**RESPONSE TO COMMENTS FOR THE
DRAFT DRAINAGE MEMORANDUM**

**Jones & Valley View Corridor Improvements
CLV Hansen No. 38800
Original Submittal dated January 27, 2011**

**Re: Response to Draft Drainage Memorandum For
Jones & Valley View Corridor Improvements, March 2, 2011
Draft Drainage Memorandum Submittal Dated January 27, 2011
CLV Hansen No. 38800
Jacobs Job #W4X52900**

Re: Jones & Valley View Corridor Improvements
70% Plan Submittal for Jones Boulevard
70% Plans for Valley View Boulevard with Draft Drainage Memorandum
Hansen # 38800, WU 8117

RESPONSE TO COMMENT 5

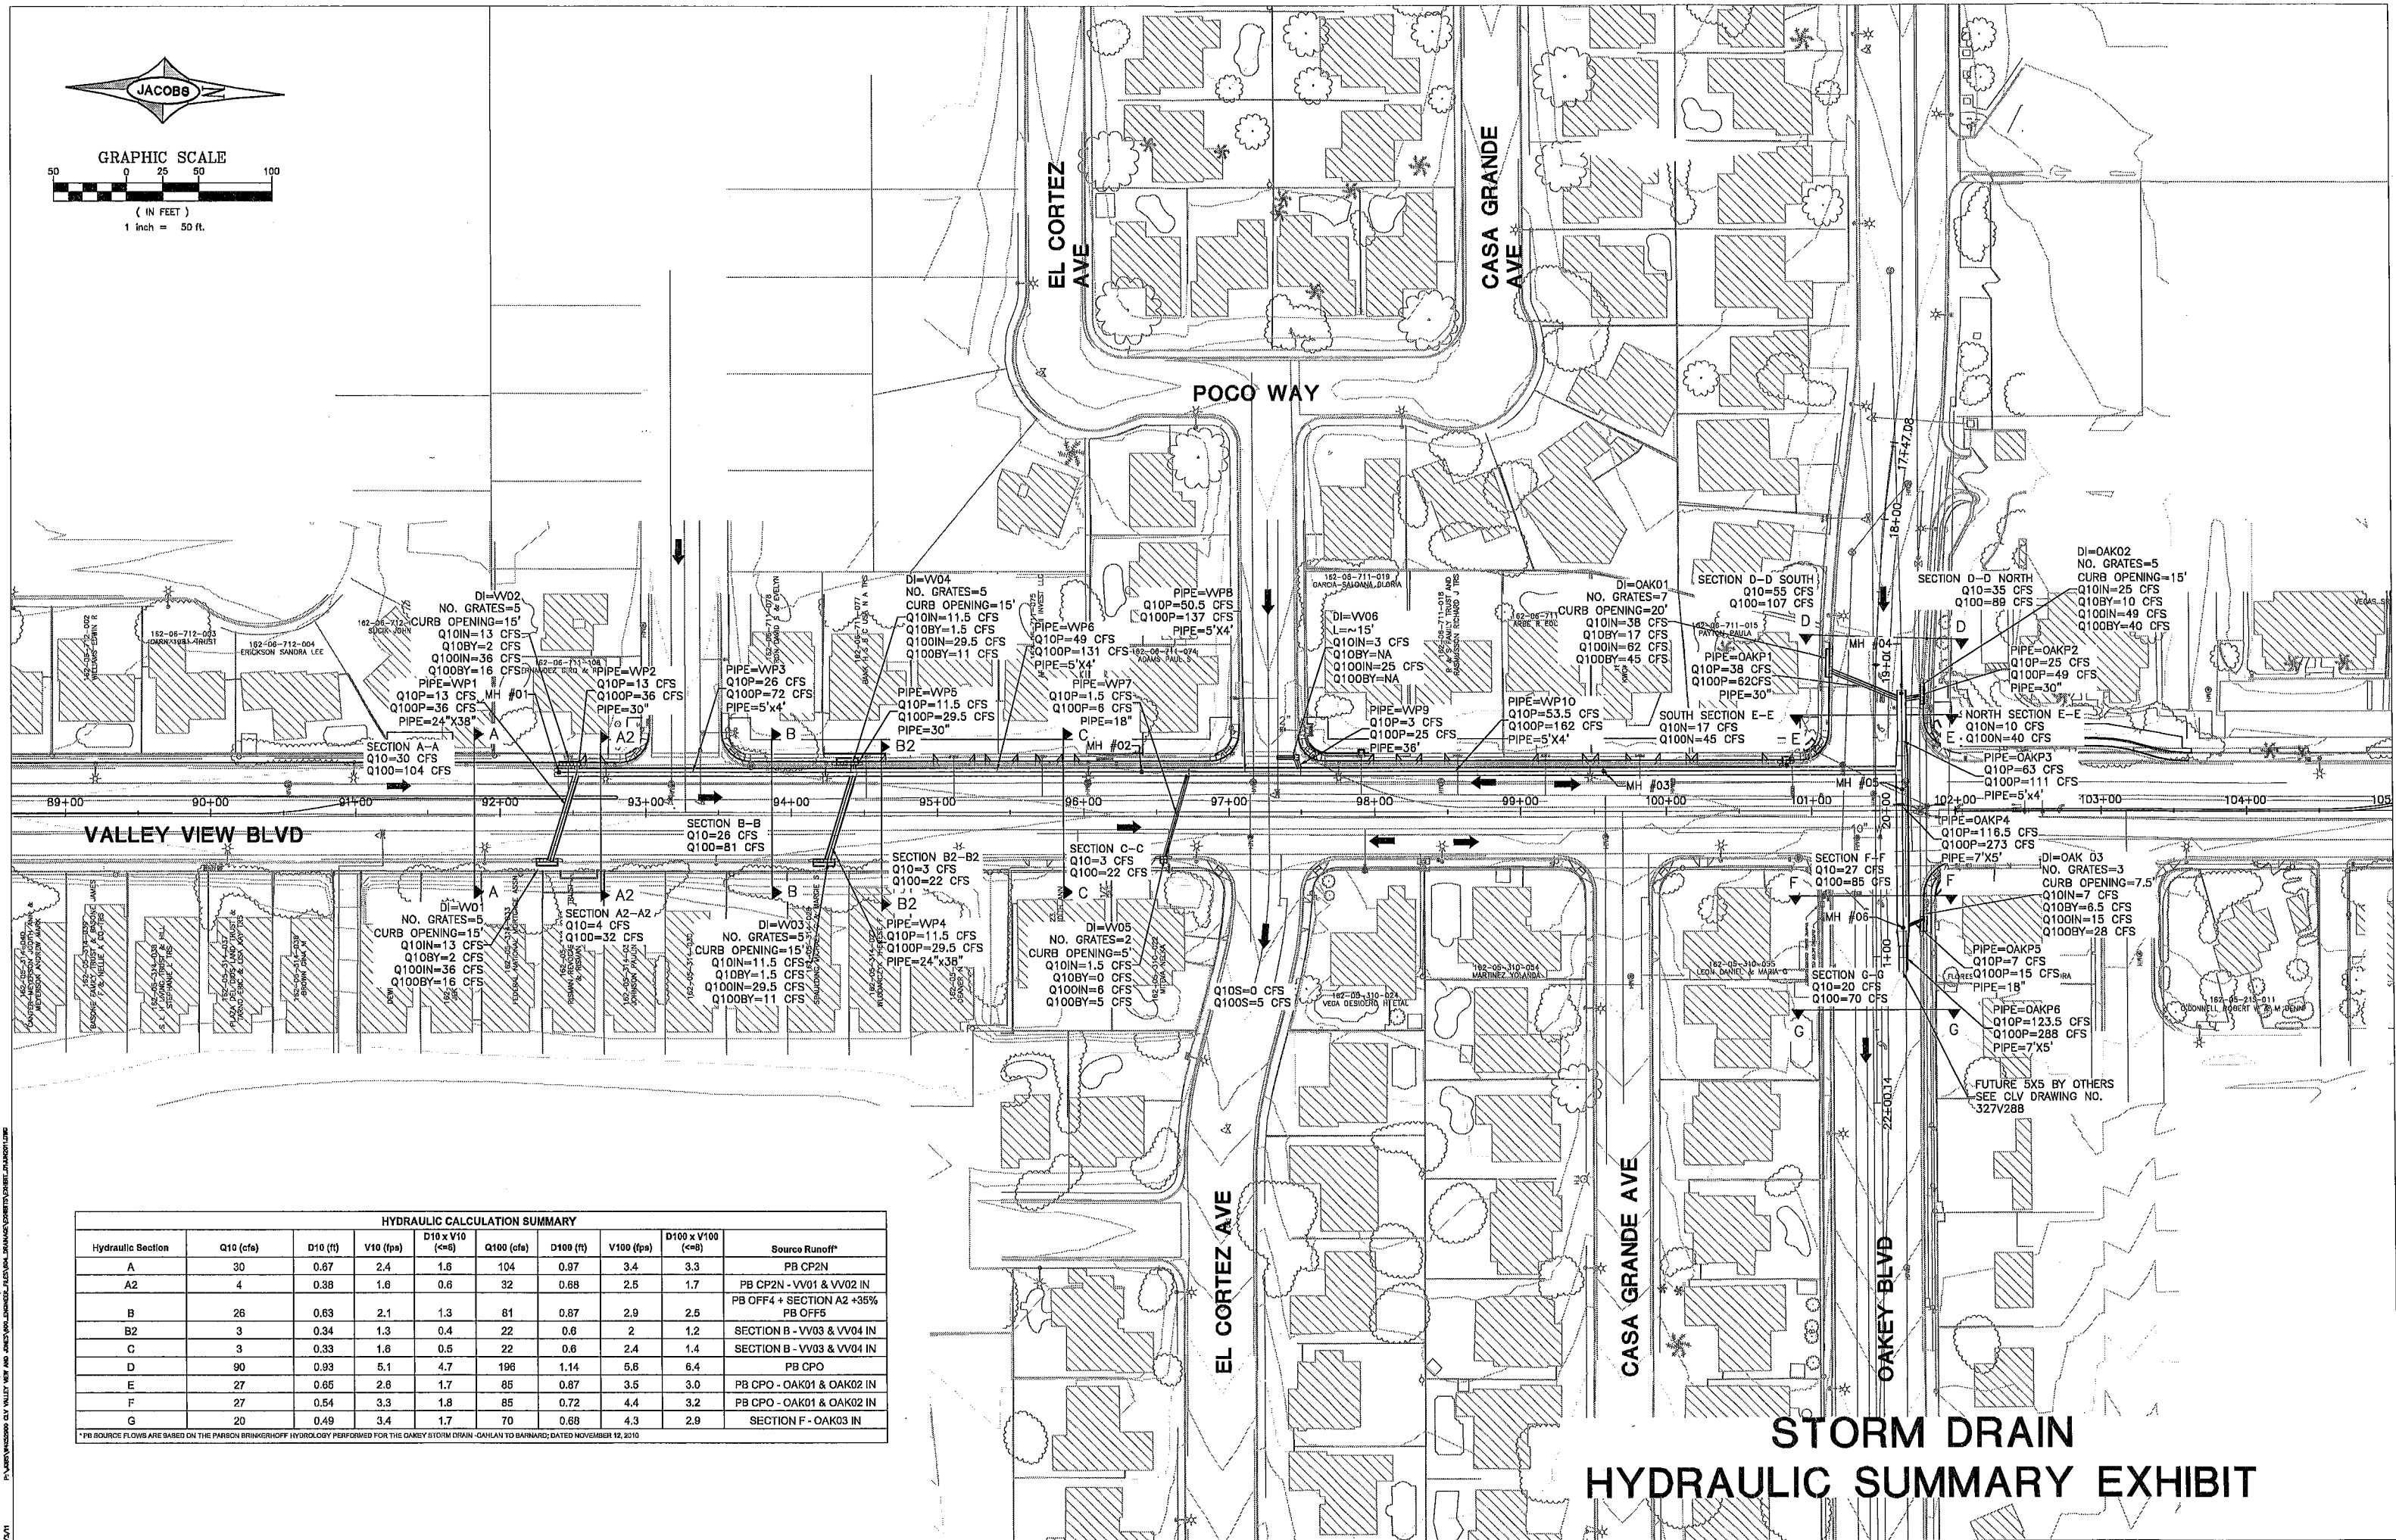
Comment 5 **Revise Table 2 to label the Q100 bypass flow.**

Response: Table 2 has been updated and is included in the Appendix of this report under COMMENT 5.
